Feathercrest and Stone Ridge Lift Stations Upgrades-Ph 3 and 4: New Feathercrest Lift Station
Solicitation Number: CO-00310-SM
Job No.: 19-2502

ADDENDUM 2
Wednesday, June 3, 2020

Seq. No. **C-101**

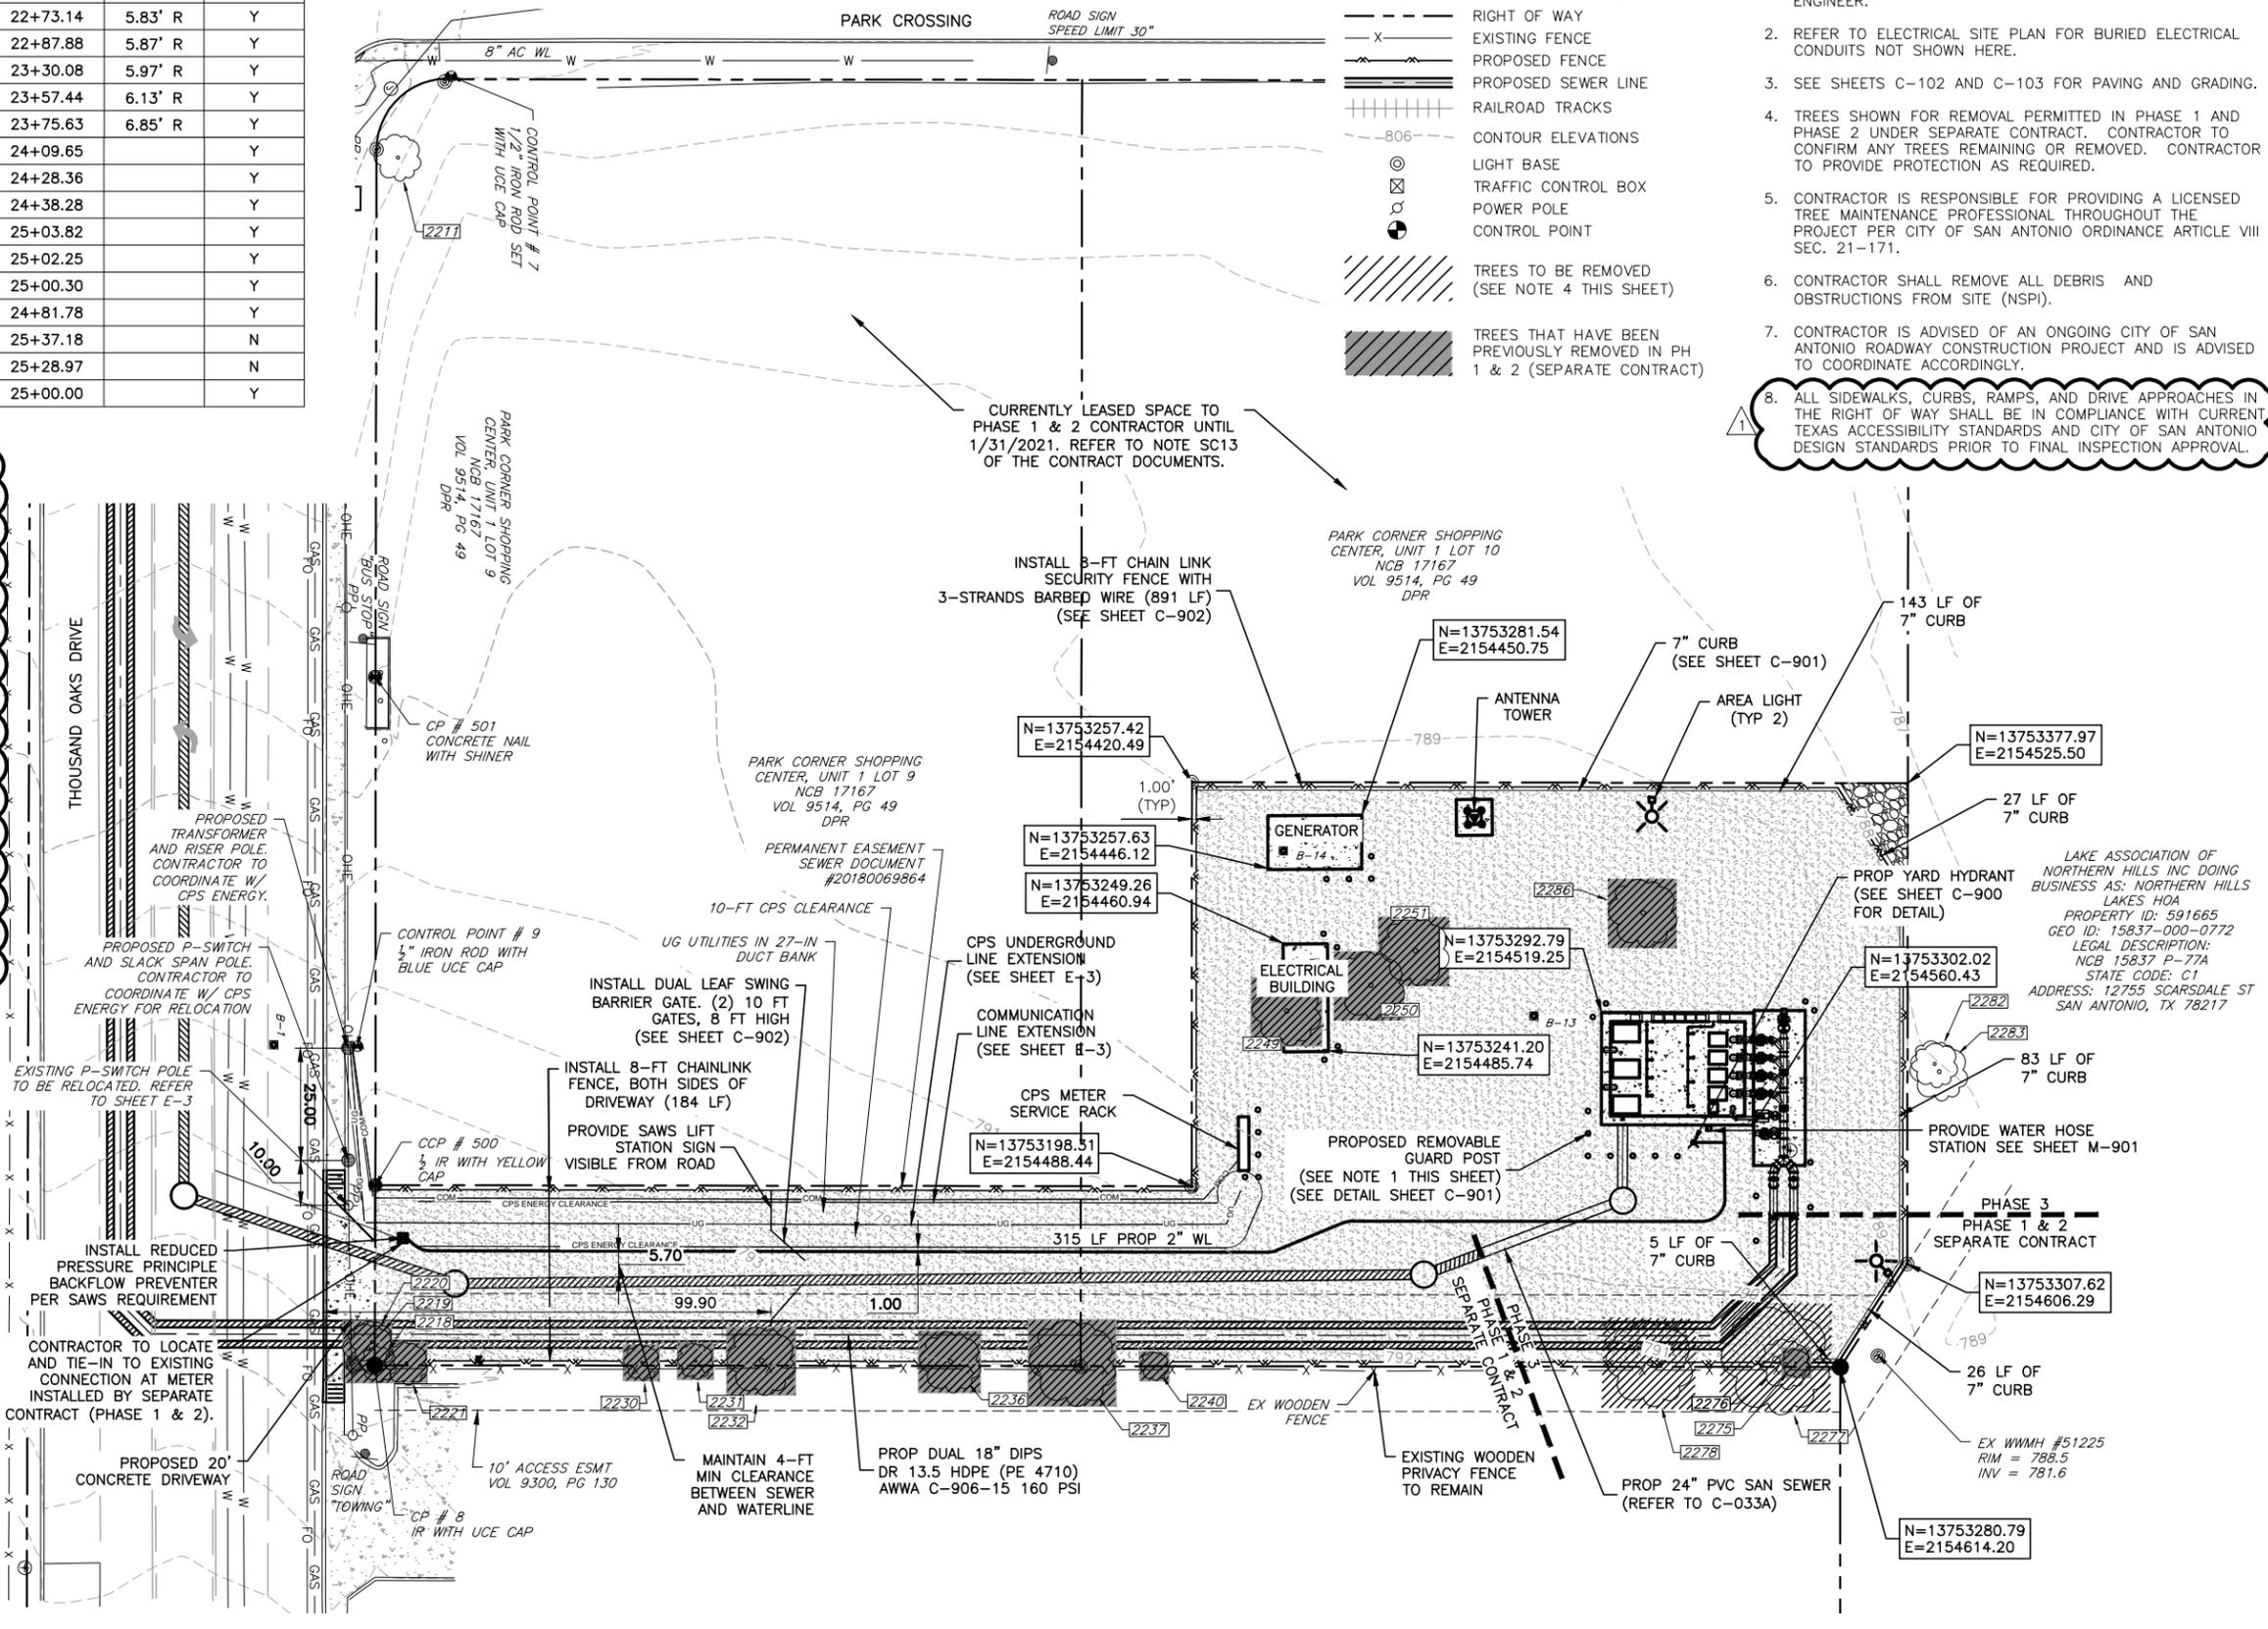
1. **Sheet C-101:**
 - a. Add Note 8: "ALL SIDEWALKS, CURBS, RAMPS, AND DRIVE APPROACHES IN THE RIGHT OF WAY SHALL BE IN COMPLIANCE WITH CURRENT TEXAS ACCESSIBILITY STANDARDS AND CITY OF SAN ANTONIO DESIGN STANDARDS PRIOR TO FINAL INSPECTION APPROVAL."
 - b. Add Tree Canopy Requirements Table.
2. **Sheet C-021-A:**
 - a. At Ex. MH 947638, Station 1+28.47, change callout to "REHABILITATE" to "RECONSTRUCT AND COAT".
 - b. At Ex. MH 947638, Station 1+28.47, add callout, "CUT AND PLUG EXISTING OUTFLOW B. CONTRACTOR SHALL REWORK INCOMING INVERT TO ACCOMMODATE DIRECTION OF THE FLOW TO THE PROP. MH 16".
3. **M-100:** Replace entire sheet with attached.

8. ALL SIDEWALKS, CURBS, RAMPS, AND DRIVE APPROACHES IN THE RIGHT OF WAY SHALL BE IN COMPLIANCE WITH CURRENT TEXAS ACCESSIBILITY STANDARDS AND CITY OF SAN ANTONIO DESIGN STANDARDS PRIOR TO FINAL INSPECTION APPROVAL.

REQUIRED TREE CANOPY PLANTING

LOT 9 (0.1448 AC.=6,307.5 SF): 6,307.5 SF *25% =1,576.9 SF OF CANOPY REQ'D

LOT 10 (0.4961 AC=21,610.1 SF): 21,610.1*25% =5402.5 SF OF CANOPY REQ'D

TOTAL = 6,979.4 SF OF CANOPY REQ'D
